**General Rate Application - Docket UE20944
Response to Interrogatories IR-61 to IR-84 from Commission Staff**

**Responses to Additional Interrogatories
IR-61 – IR-84
from
Commission Staff**

**General Rate Application
UE20944**

FIGURE 1
POTENTIAL CT4
LOCATION OPTIONS

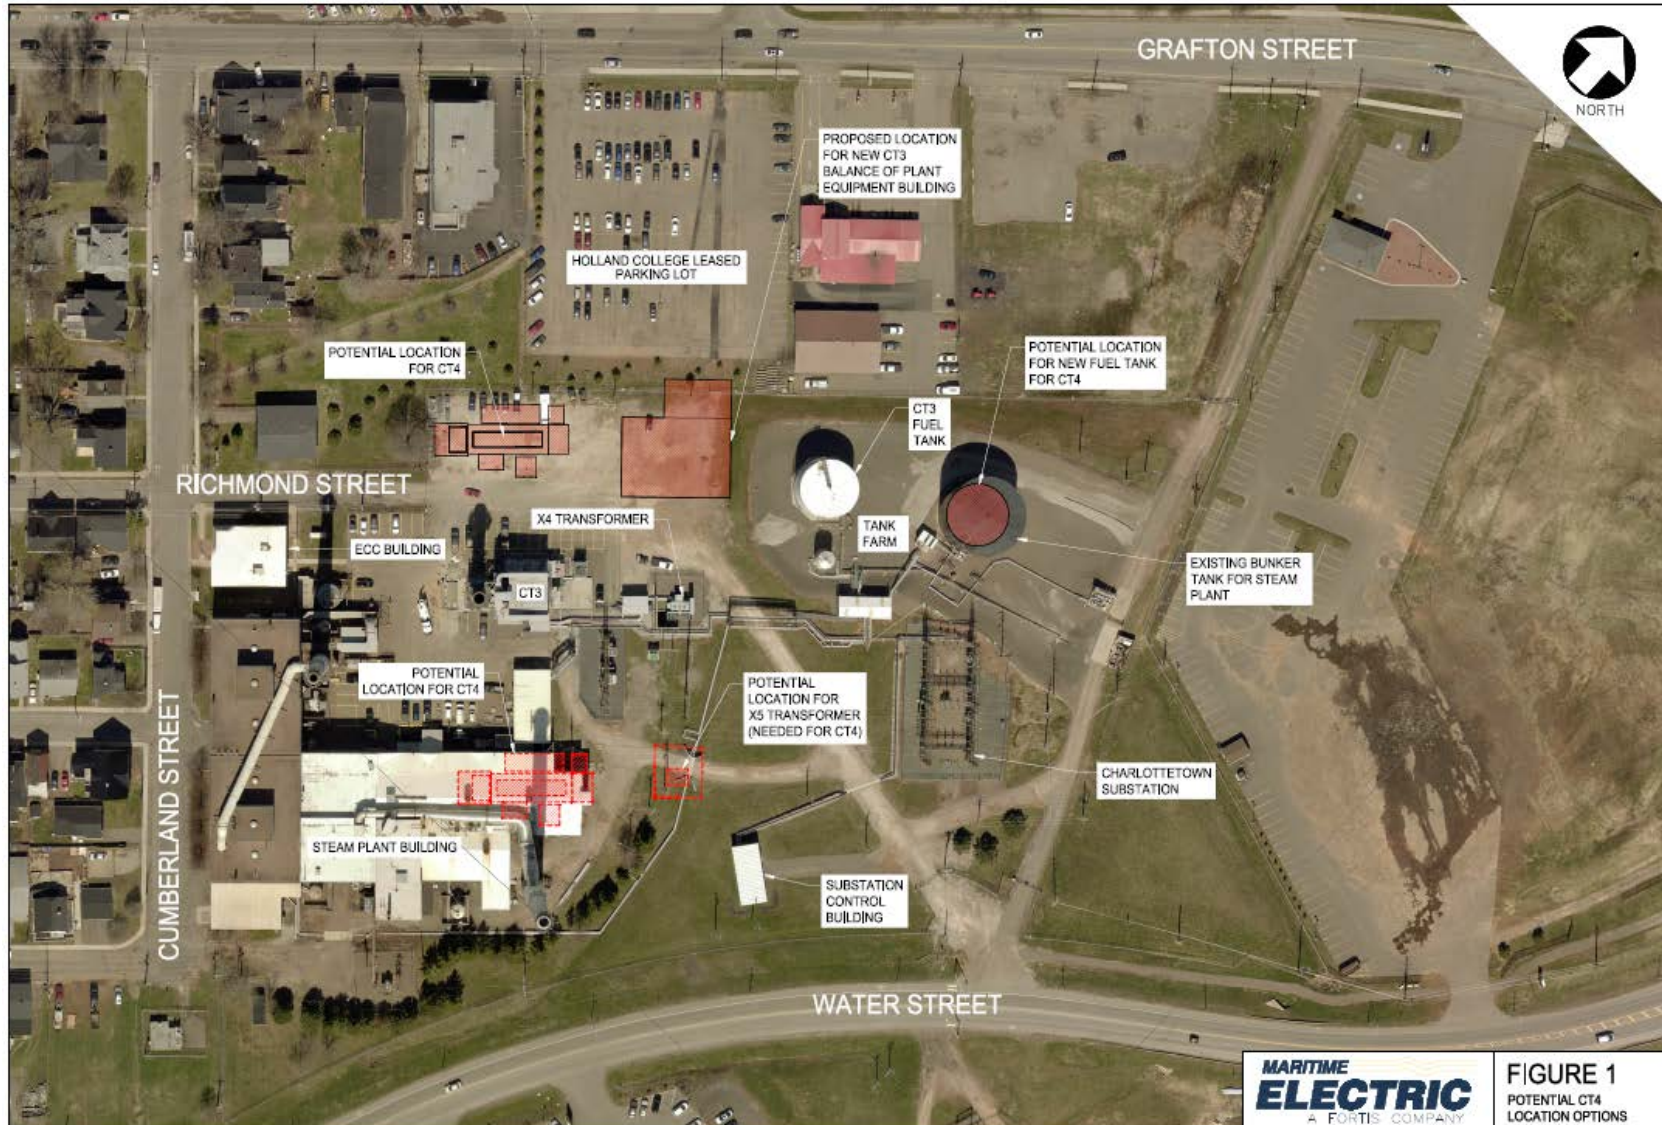
IR-66 In response to **IR-9**, MECL indicates that the CTGS site will remain used and useful to ratepayers.

- a. Please explain how the entire remaining property meets the criteria for used and useful.
- b. Please provide a tentative timeline for future development projects at this site.

In the longer term, this land will provide Maritime Electric with the ability to locate additional on-Island generation or other generation alternatives (i.e. battery storage). IR-66 - Attachment 1 shows a potential future use of the site to locate future generation. In this attachment, there are two potential locations for future generation shown. One location is to the north of CT3 and the other potential location is to the south of CT3. Each location has different advantages and disadvantages which would have to be carefully weighed if future generation were to be constructed. IR-66 – Attachment 1 also shows the proposed location for a new CT3 Balance of Plant (BOP) Equipment Building to the north of CT3.

138 kV Lines (L1142, L1143 and L1244) and associated 138 kV Submarine Cables

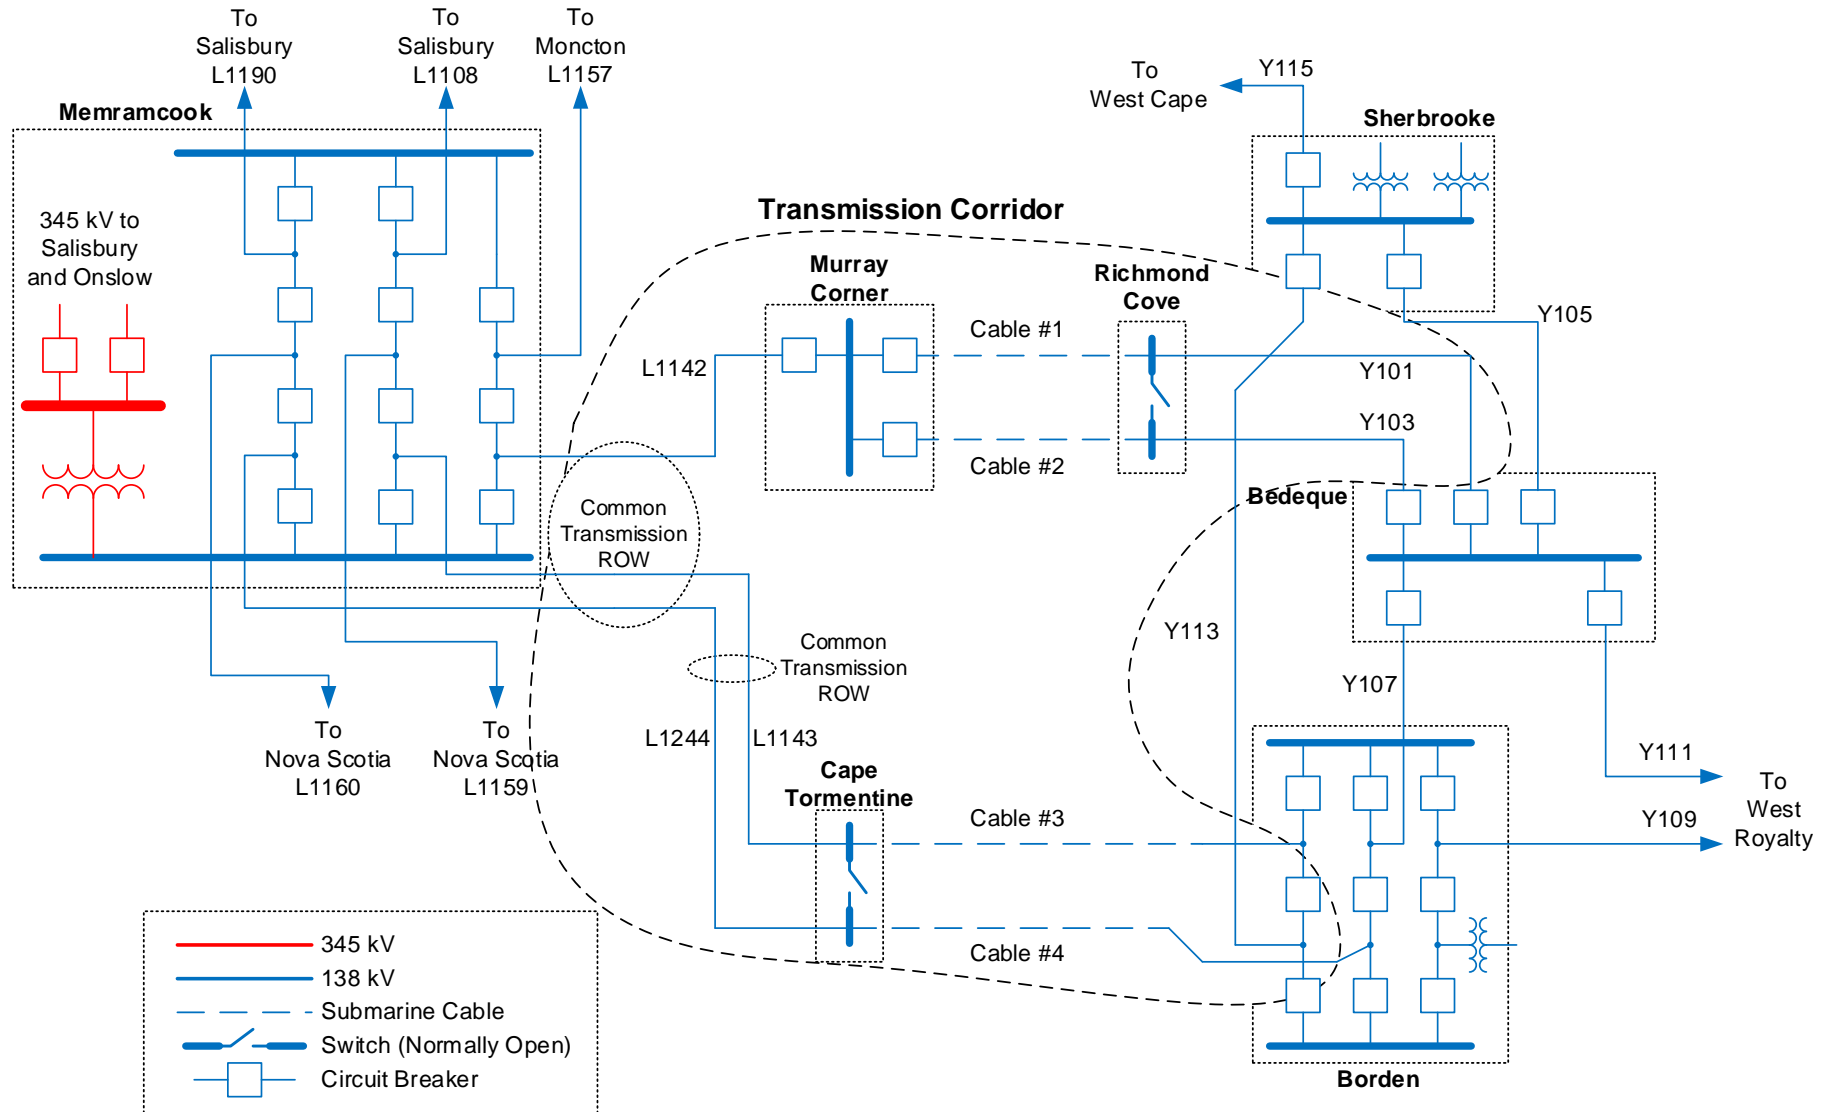
IR-73 In response to **IR-22**, Maritime Electric states that once CTGS is decommissioned, Maritime Electric will be obtaining 60% of its generating capacity from off-Island sources through a single transmission corridor. Maritime Electric also states that additional on-Island diesel-fired combustion turbine generation would reduce the impact of a loss of the transmission corridor. In 2015, Maritime Electric submitted an application to the Commission seeking approval to purchase a 50 MW combustion turbine (Commission Docket UE20723). This application was ultimately withdrawn by MECL as it had procured access to 50 MW of firm capacity.

- e. Is the loss of the transmission corridor in its entirety considered an N-1 transmission event or an N-2 transmission event?
- f. Does good utility practice require MECL to provide capacity support for the loss of the transmission corridor?

The term 'transmission corridor' in this response to questions 73 a)-h) refers to the three 138 kV lines (L1142, L1143 and L1244) and associated four 138 kV submarine cables that connect the Memramcook Substation in New Brunswick to the Richmond Cove Riser Station and Borden Riser Station in PEI, as can be seen in the diagram attached in IR-73 – Attachment 1.
